Access Compliance Report Public Rights-of-Way (Curb Ramps)

Main Street: MASON_LN Cross Street: WINFIELD_DR Location: NE

ADA ID: RPRK211025123815 Ramp Type: Type 4 - Parallel Initial Pass/Fail: Fail Overall Compliance: No Severity Score: 2

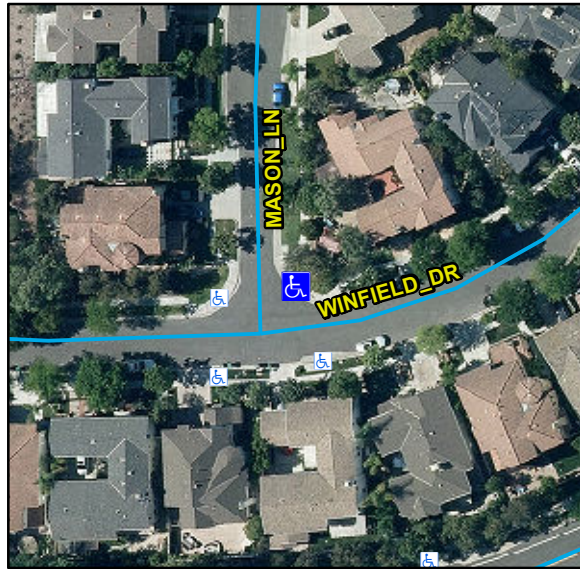
R304.2.2, R204.3, R304.5.3, STD 1115

Remove & Replace Curb Ramp With Two New Directional Ramps or Equivalent.
